Final Report - Corrections Required **Application No. LUPL-25-0008**

Document Filename : 241010_BLR Village C Land Use Plan.pdf

BANNING LEWIS RANCH - VILLAGE C

BANNING LEWIS RANCH - VILLAGE C
LAND USE PLAN
COLORADO SPRINGS, CO
COVER SHEET

**BANNING LEWIS RANCH - VILLAGE C
LAND USE PLAN
COLORADO SPRINGS, CO
LAND USE PLAN**

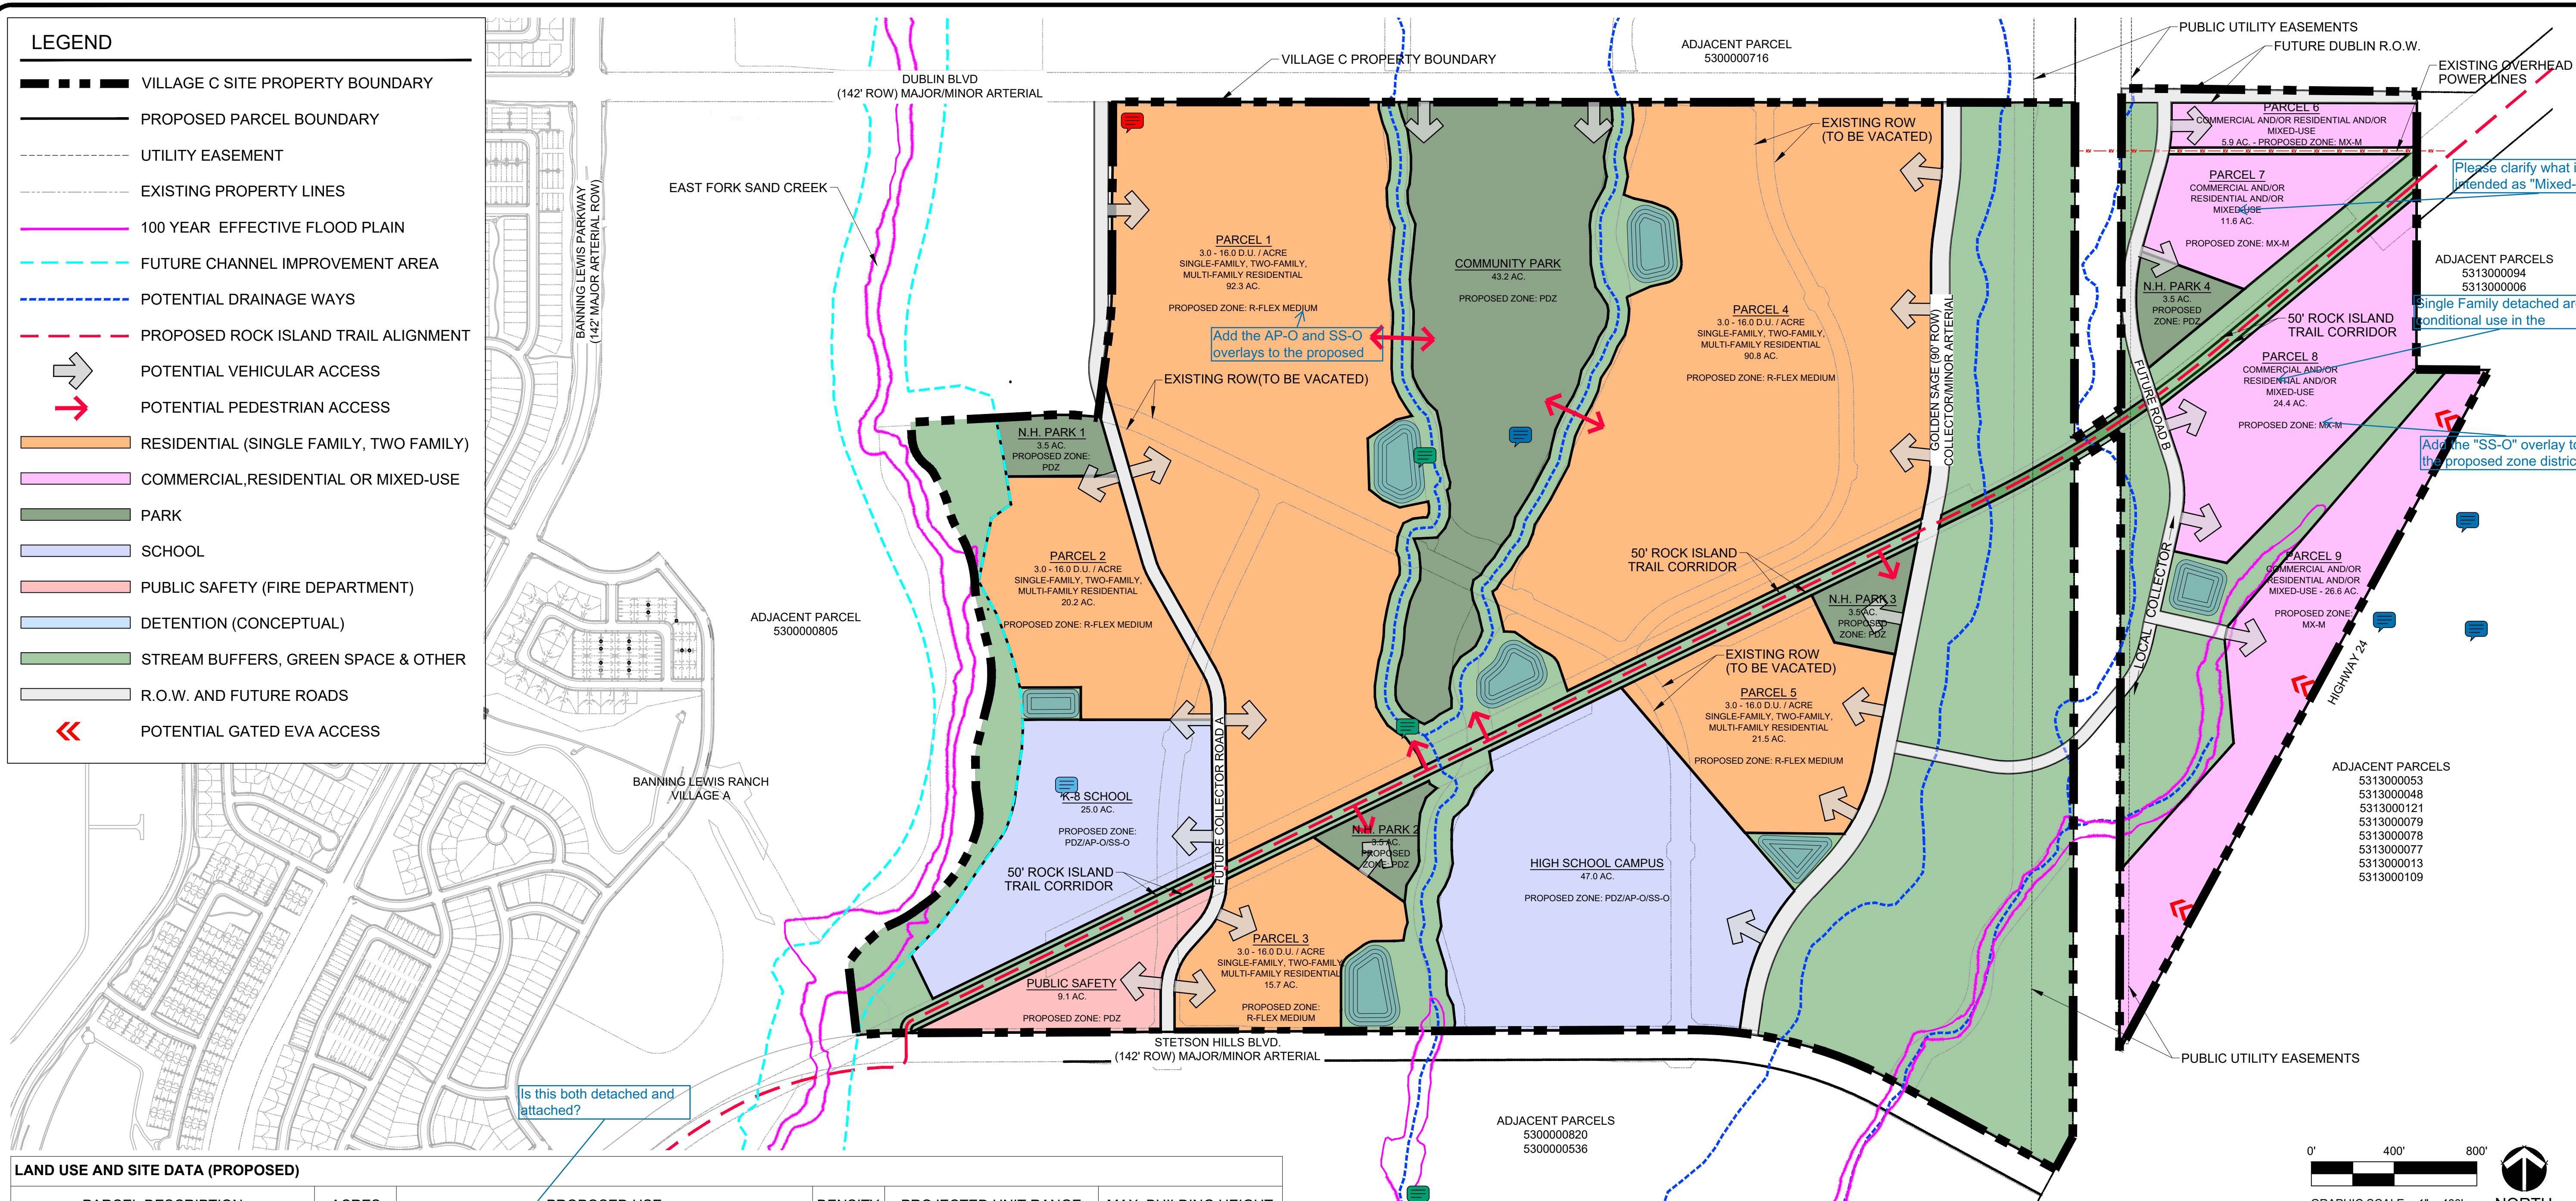
Comment ID	Page Reference	Reviewer : Department	Review Comments
16	2	Caroline Miller : Planning	Informational - More Parks comments or edits are likely to be requested.
19	2	Caroline Miller : Planning	Please revise all proposed zones - PDZ for Parks and Schools is no longer proposed.
21	2	Caroline Miller : Planning	As shown, there is a need for pedestrian bridges to allow connection to the Community Park site. Will the developer provide those?
22	2	Caroline Miller : Planning	As communicated with the developer team, May 2025, BLR Village A is to be viewed as a separate development, removing the Community obligation of Village A from Village C. Please remove all references to Village A acreage. PLDO reviewer acknowledges that with this direction, the Community Park size is required to meet B2 & C obligations is 28.7 acres, though additional acreage would be supported in creating a larger, more versatile site, and better meeting Community Park Site characteristics.

23	2	Caroline Miller : Planning	Please add Village B2 Community Park acreage to table, as it is carried over from Village B2.
24	2	Caroline Miller : Planning	Please recalculate math for Community Park obligations for Village C and B2. Reviewer calculates 11.568 for Village C and 17.128 for Village B2 with units shown.
26	2	Caroline Miller : Planning	Please confirm, in prior LUP Review (PDZL-24-0005) 1,841 units were used as an average for PLDO calculations. Now, this number has been revised to 1,446 to account for 6 du/ac (Note 1) where the mean unit count is now 2,285. Please confirm with staff which count is more accurate. Typically staff would go with average.
28	2	Caroline Miller : Planning	Notes 2 and 4 need to be updated with accurate acreages and reflect that Village A is no longer included.
29	2	Caroline Miller : Planning	Staff sees 4 3.5 acre parks totaling 14 acres of Neighborhood Parks. Are there any notes that need to be added regarding the 4th park site considering future multifamily development? Is the intent that the future multifamily development will be meeting Neighborhood Park PLDO through this dedication, with Community Park fees in lieu due? Staff is supportive of the eastern 4th park site, as it is geographically separate from the rest of Village C and a benefit to the residents there.

32	2	Allison Stocker : Planning	Label creek name and type
42	2	Tamara Baxter : Planning	Refer to EPC, EPC Engineering and District 49 comments which were uploaded to file.
43	2	Tamara Baxter : Planning	Please see separate email dated 6.25.25 from City Budget Office sent separately.
44	2	Tamara Baxter : Planning	Single Family detached are conditional use in the MX-M zone district.
45	2	Tamara Baxter : Planning	Please clarify what is intended as "Mixed-Use", does this anticipate more than commercial and residential per UDC?
46	2	Tamara Baxter : Planning	Add the AP-O and SS-O overlays to the proposed zone district labels.
47	2	Tamara Baxter : Planning	Add the "SS-O" overlay to the proposed zone district labels
49	2	Tamara Baxter : Planning	Is this both detached and attached?
50	2	Tamara Baxter : Planning	This range does not include the proposed residential density in parcel 6, 7, 8 and 9.
52	2	Tamara Baxter : Planning	The UDC does not define Mixed-Use. Can you please clarify. Does this encompass the uses that are allowed or conditional in the MX-M zone district? Are there uses that you want to restrict?

53	2	Tamara Baxter : Planning	Please use this on the coversheet as well.
54	2	Tamara Baxter : Planning	What does this residential encompass?
30	3	Caroline Miller : Planning	This graphic doesn't match the LUP Bubbles shown on page 2, park is not next to Public Safety.

Please use this on the coversheet as well.
